T.I. no.: 2016 - 13 Updated: -	Topic: Integrated water pump connection NRV
---	--

Date: 23/11/2016
Affected machines: Schaerer Coffee Art Plus
From serial number: -
As of date: -

INTEGRATED NRV IN SCREW CONNECTION FOR WATER PUMP

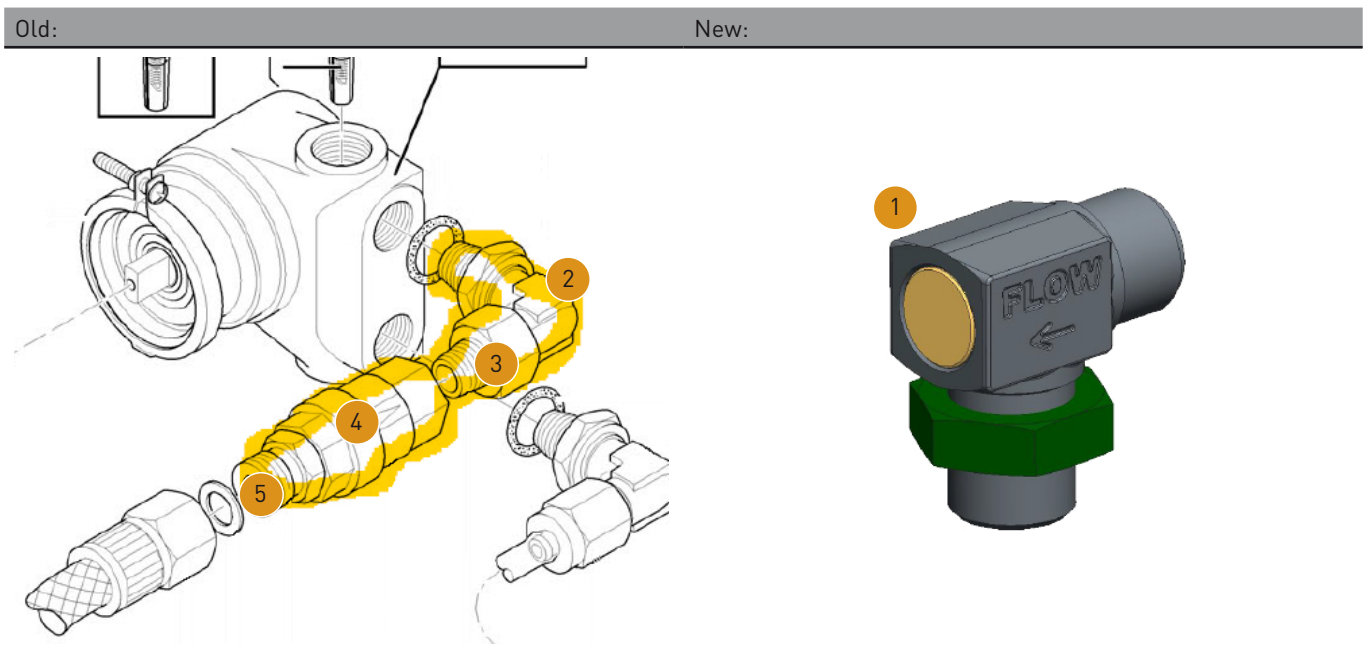
New component 074266 is a pump connection with integrated non-return valve and can be installed directly on the water connection hose. Items 2-5 are no longer part of the system. The insert in the screw connection cannot be replaced. The connection is inserted in the new SCAs.

In case of repair, the NRV can be additionally inserted into machine types such as the TWIN, SCC and SM2
